# UNITED STATES PATENT AND TRADEMARK OFFICE

APPLICATION NO.	FILING DATE	FIRST NAMED INVENTOR	ATTORNEY DOCKET NO.	CONFIRMATION NO.
10/773,275	02/09/2004	Franz Sieberer	2004-0129A	8571

<b>Advisory Action</b> <b>Before the Filing of an Appeal Brief</b>	<b>Application No.</b> 10/773.275	<b>Applicant(s)</b> SIEBERER, FRANZ	
	<b>Examiner</b> Ernesto Garcia	<b>Art Unit</b> 3679

Fig. 3b

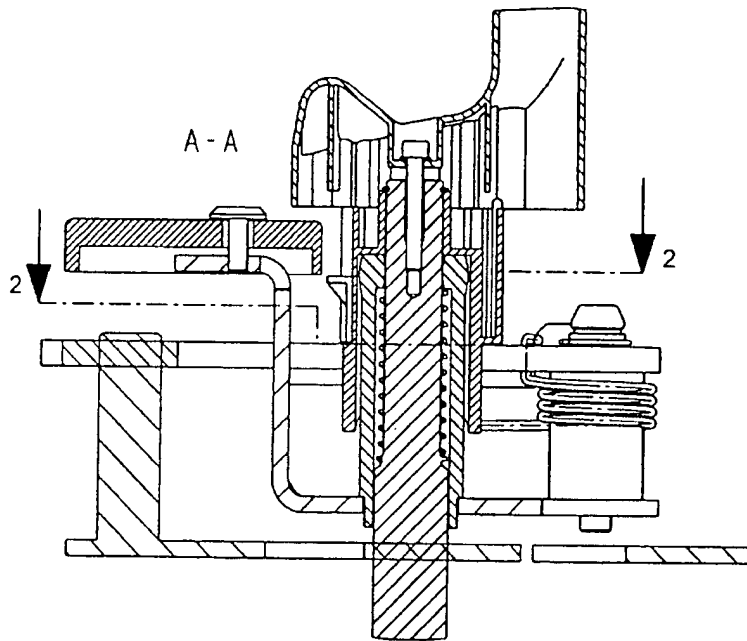
Continuation of 13. Other: The drawings filed on 12/23/05 are not acceptable. Figures 8b and 11b show the spring 12 embedded in the pin 6. The use of solid black lines to show cross hatching in Figure 11c is not permitted. The ends of the broken lines in Figures 2a, 2b, 3a, 3b, 4b, 6a, 6b, 7a, 7b, 8a, 8b, 9a, 9b, 10a, 10b, 11a, and 11b should be designated by Arabic or Roman numerals corresponding to the view number of the sectional view. See 37 CFR 1.84(h)(3) and MPEP 608.02(e). Note that the broken line in Figure 2a should be 2b and not 1 as there is no Figure 1 showing view number 1-1. Further, the legend A-A, B-B, etc. in the views should be deleted. Further, what is going on with the pin 4 in Figures 3b and 3c? Is the pin bisecting the hook 10?
